BROWNS FERRY NUCLEAR PLANT (BFN) - UNIT 2 - AMERICAN SOCIETY OF MECHANICAL ENGINEERS (ASME) SECTION XI INSERVICE INSPECTION (ISI) PROGRAM, REQUEST FOR RELIEF 2-ISI-18 - RESPONSE TO NRC REQUEST FOR ADDITIONAL INFORMATION

TENNESSEE VALLEY AUTHORITY
BROWNS FERRY NUCLEAR PLANT (BFN)
UNIT 2

AMERICAN SOCIETY OF MECHANICAL ENGINEERS (ASME)
SECTION XI, INSERVICE INSPECTION (ISI) PROGRAM
REQUEST FOR RELIEF 2-ISI-18

RESPONSE TO NRC REQUEST FOR ADDITIONAL INFORMATION

Weld RWCU-2-003-G003

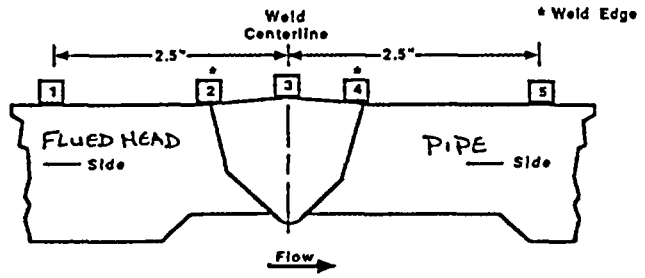
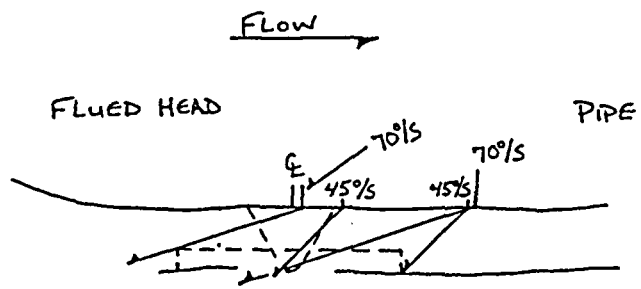
For RR 2-ISI-18, the coverage of welds KR-2-25 (pipe to tee) and RWCU-2-003-G003 (pipe to flued head) is less than the required 100 percent volumetric examination coverage. Please address the following:

TVA stated that 50 and 75 percent coverage, respectively, for the above welds under the current ASME Section XI requirements are the maximum achievable coverage; however, another statement was made that 100 percent coverage under the requirements of the original ASME Section XI was achieved. Discuss the reason for the difference in coverage when the weld configuration is the same. Please provide a drawing of the weld configuration, showing the location of the obstructions. Also, provide a listing of ultrasonic (UT) examination reports, with transducer angles, coverage per scan direction, flaws and flaw location (if any). The information requested may be similar, but not limited to, the information provided for RR 2-ISI-19.

TVA stated that the performance of the UT examination of the subject areas, to the maximum extent practical, provides an acceptable level of quality and safety because the information and data obtained from the volume examined provides sufficient information to judge the overall integrity of the piping welds. The technical bases provided in the submittal did not clearly address why the reduced coverage is sufficient to assure the integrity of the welds. Please discuss why the information and

data obtained from the reduced coverage will ensure the integrity of the weld configuration for the remainder of the Third Inservice Inspection Interval.

As shown on the attached weld profile sheets, weld KR-2-25 coverage equals 50 percent because the joint configuration contains a non-parallel surface on the downstream side of weld centerline that limited scanning in the circumferential directions. This limitation does not exist in Weld RWCU-2-003-G003 and 75 percent coverage was achieved.

Ultrasonic examination reports for weld RWCU-2-003-G003:

- Report R-124, dated 3/5/03:
 - o Transducer angles: 45 degree shear, 70 degree shear
 - o Scan direction coverage:
 - Down stream side - 100 percent
 - Upstream side - 0 percent
 - Clockwise - 100 percent
 - Counterclockwise - 100 percent
 - o Flaws: None

- Report R-0284, dated 4/2/93
 - o Transducer angles: 45 degree shear, 60 degree RL
 - o Scan direction coverage: 100 percent on all scans
 - o Flaws: None

75% TOTAL REQUIRED EXAM COVERAGE
